RFQ NUMBER
DEP13005

BENHAM GROUP 120-79

LINE	QUANTITY	UOP	CAT. NO.	ITEM NUMBER	UNIT PRICE	AMOUNT
0001	1	JB		962-73		
<p>***** ADDENDUM NO. 1 *****</p> <p>ADDENDUM ISSUED FOR THE BENHAM PROJECT TO DISTRIBUTE THE PRE-BID SIGN-IN SHEET FROM THE 08/28/08 MANDATORY PRE-BID MEETING, THE Q/A, THE REVISED SPECIFICATIONS, AND BID SCHEDULES RESULTING FROM THAT MEETING.</p> <p>BID DATE & OPENING HAVE BEEN EXTENDED FROM 10/01/08 TO 10/08/08 AT 1:30 PM</p> <p>PLEASE NOTE- IN ACCORDANCE WITH WV CODE 21-1D-5, BIDS FOR CONSTRUCTION CONTRACTS MUST CONTAIN A SIGNED PURCHASING AFFIDAVIT WITH THE BID. FAILURE TO SUBMIT THE SIGNED PURCHASING AFFIDAVIT WITH THE BID SHALL RESULT IN DISQUALIFICATION OF THE BID.</p> <p>***** NO OTHER CHANGES *****</p> <p>RECLAMATION: RESTORATION OF LAND</p>

BENHAM GROUP 120-89
ADDENDUM #1**CHANGES TO SCOPE OF WORK AND TYPICALS**

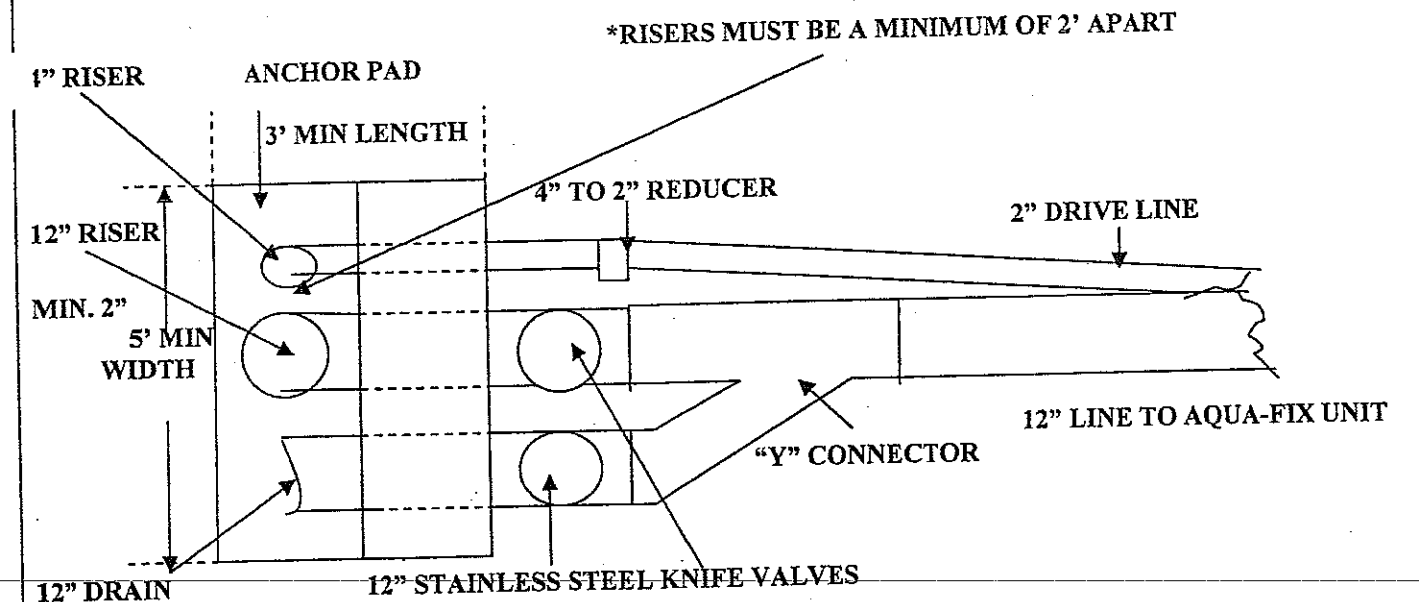
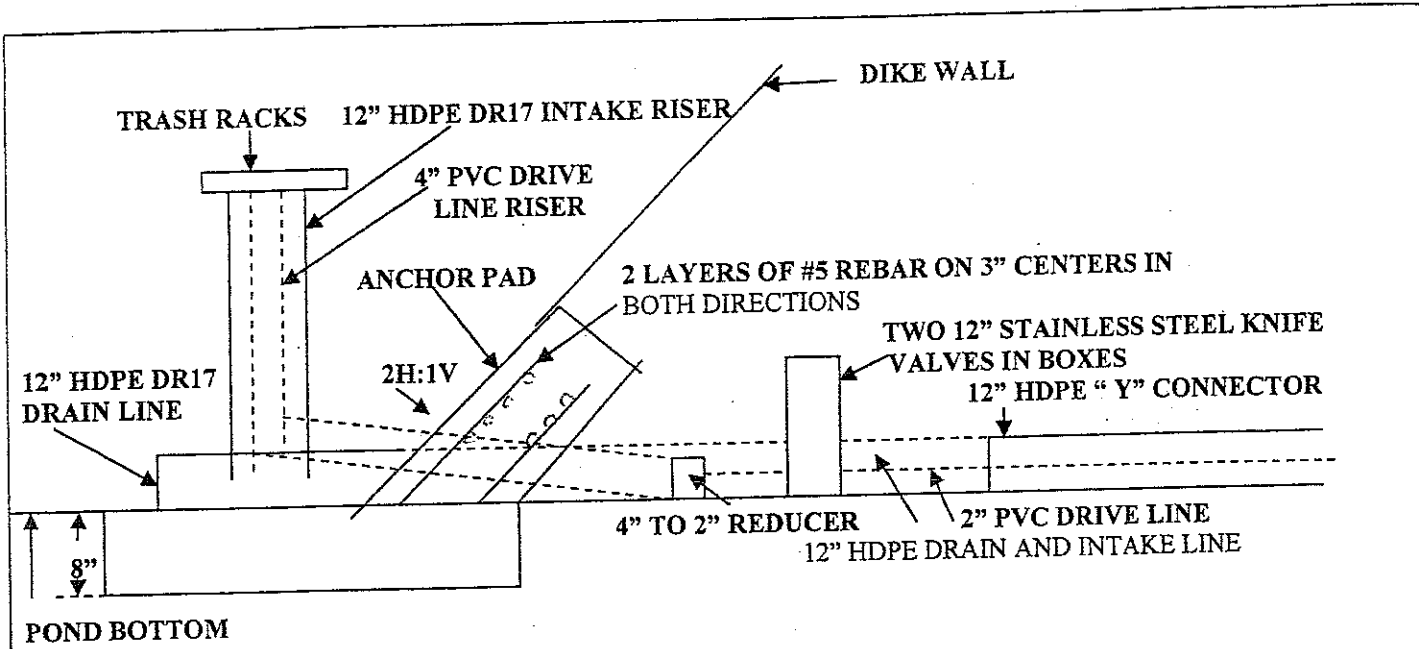
- 7) Page 78, “RAW WATER POND TYPICAL” , and page 79, “RAW WATER POND STAND PIPE ANCHOR PAD TYPICAL”, have been changed to show only two (2) risers and one (1) drain line. Also, on the RAW WATER POND TYPICAL, change “SPLAHPAD” to read “SPLASHPAD”. On the RAW WATER POND STAND PIPE ANCHOR PAD TYPICAL, change.... “ONE 12” AND ONE 4” SCHEDULE 40 PVC RISERS” HDPE DR17 RISER ...to read ...ONE 12” HDPE DR 17 RISER AND ONE 4” PVC RISER”. Note that the typical also shows the dike wall continuing past the anchor pad and the rebar in the anchor pad is shown to run horizontal as well as vertical. (New typicals have been attached.)
